ECN/PCN No.: 4331

For Manufacturer			
Product Description: 32.768kHz SMD Low ESR Crystal	Abraccon Part Number / Part Series: ABS07-LR	<input type="checkbox"/> Documentation only <input checked="" type="checkbox"/> ECN <input type="checkbox"/> EOL	<input checked="" type="checkbox"/> Series <input type="checkbox"/> Part Number
Affected Revision: B	New Revision: C	Application:	<input type="checkbox"/> Safety <input checked="" type="checkbox"/> Non-Safety

Mechanical Dimensions:

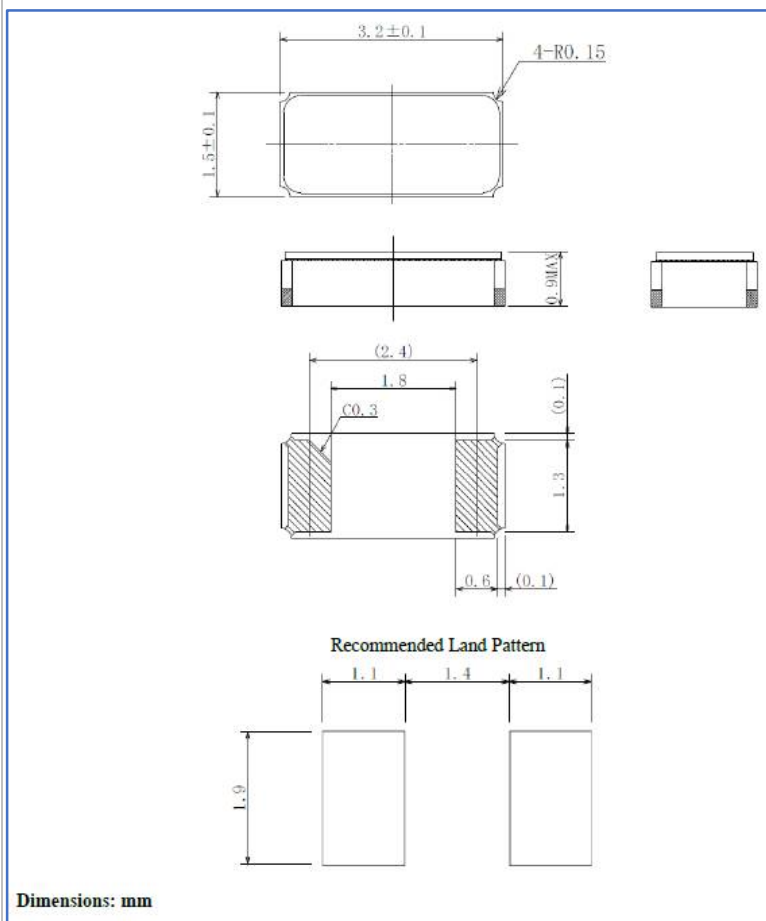
- Added Alternative Mechanical Dimensions #1

Abraccon introduced additional manufacturing sources to ensure product availability and to be in a better position to meet long term customer demand. Added an alternative bottom packaging structure to reflect the product produced by all manufacturing sources.

Change Declaration:
The added bottom packaging structure does not impact the electrical performance of the device.
